GATS2.4 – Expands to DD15 in 2025

Required Aftertreatment Changes

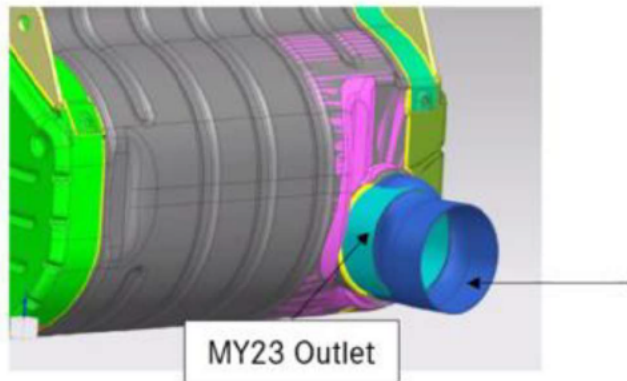
- SCR substrate length increased to 12 Inch.
- Currently 6-4; will change to 6-6 length.
- Outlet saddle (internal to the ATD) being flattened to allow for longer SCR.
- No change to axial outlet.
- Modifications required for in-board exhaust.
